New York State Department of Environmental Conservation  
50 Wolf Road, Albany, New York 12233

Re: Operations & Maintenance Inspection Report  
NYD002239440

**OPERATIONS & MAINTENANCE  
INSPECTION (O & M)**

**FISHER GUIDE DIVISION  
GENERAL MOTORS CORPORATION**

FIGURE 1

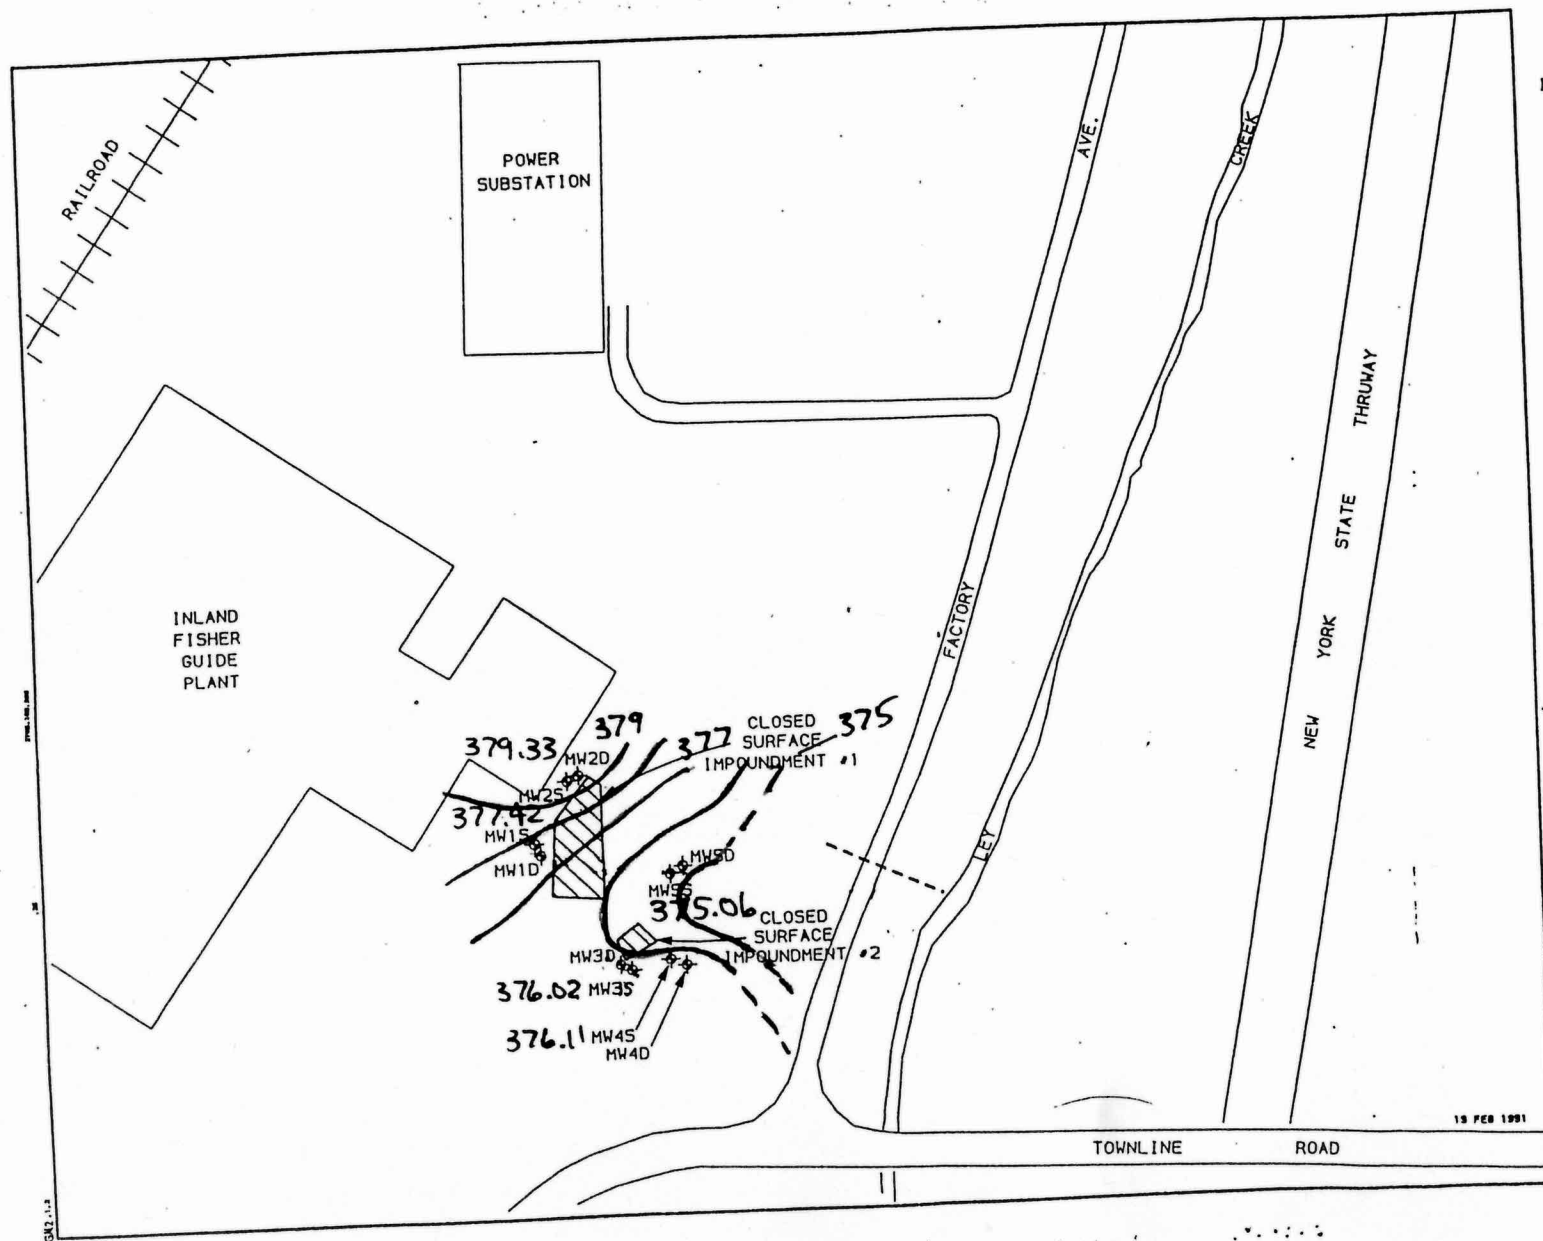
One minor deficiency was noted. Wells MW-3S and MW-3D are shown incorrectly on the base map. MW-3D is to the south of MW-3S. Please submit a new map within 30 days of the date of this letter.

FIGURE 2

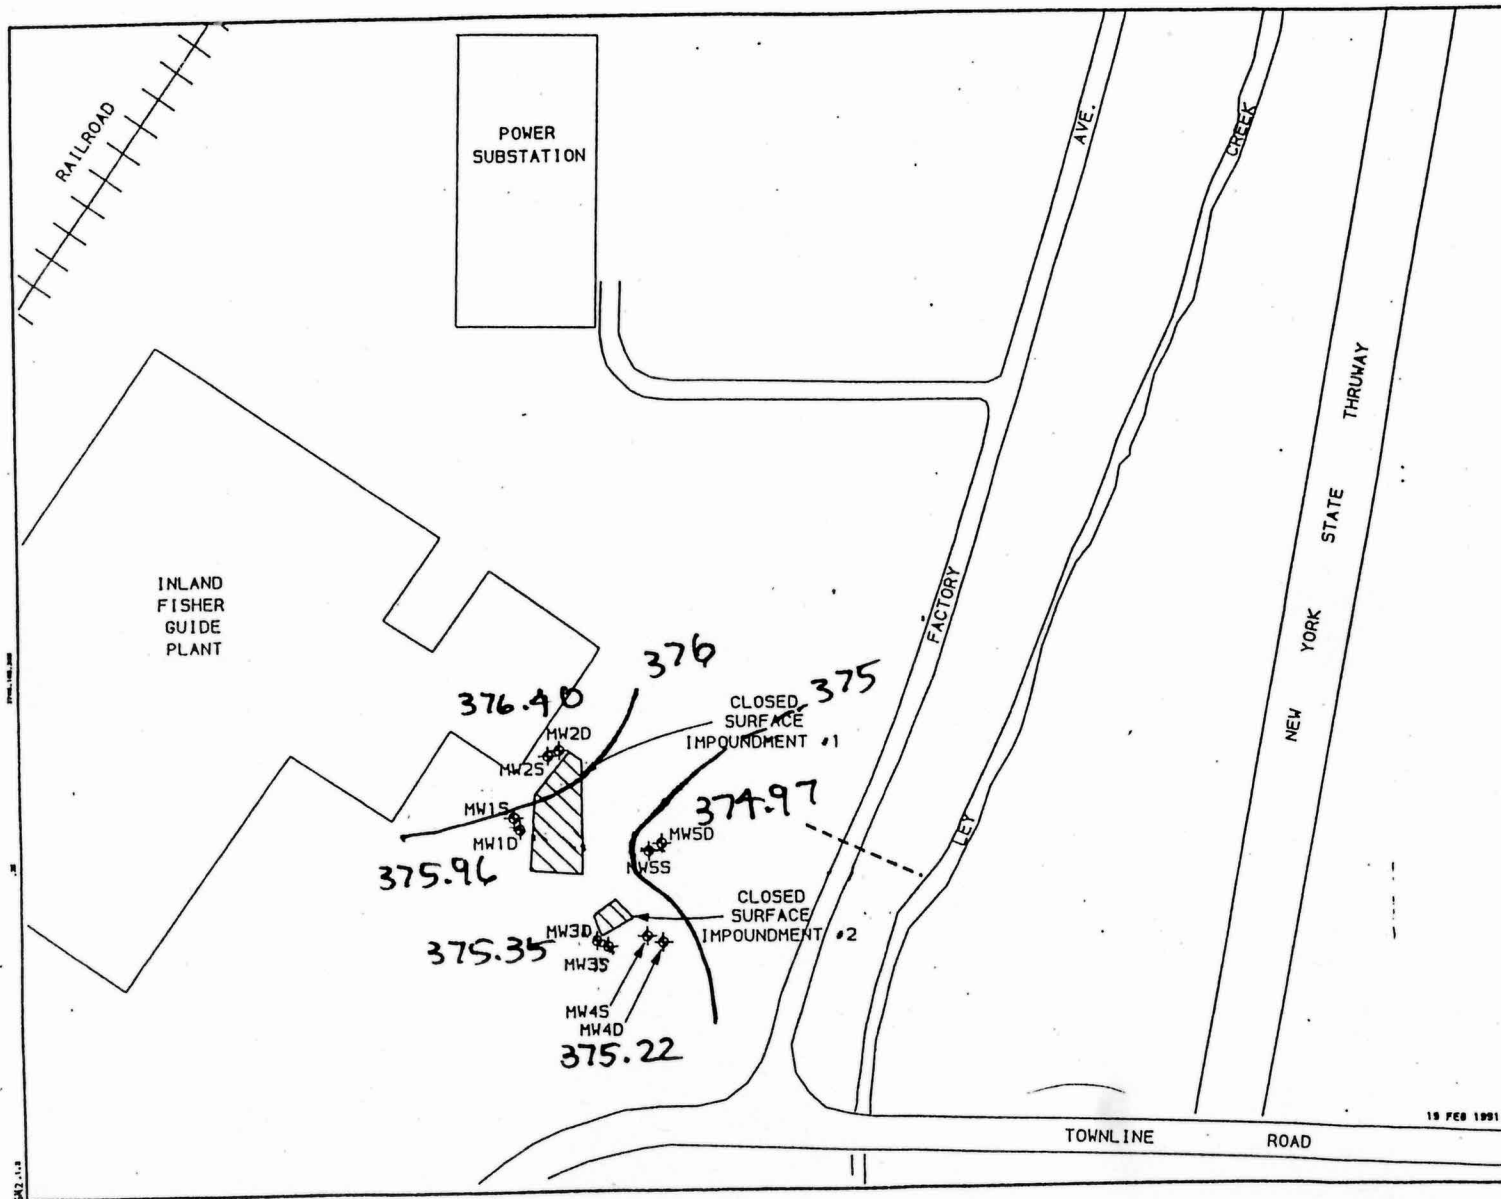
10. Groundwater elevation data was collected and potentiometric contour maps developed from this data (see Figures 2 and 3). Based on this information, IFG's decisions as to the number and location of monitoring wells in the network for detection monitoring appear to be appropriate. Monitoring well MW-3D did have a water level in September of 1991 that was not consistent with the previous data and did appear to change the deeper groundwater flow direction. IFG has been instructed to notify the Department if any low groundwater elevations are observed again. Further investigation will then be necessary (additional water level readings). If this phenomena is repeated, additional downgradient wells may need to be installed.
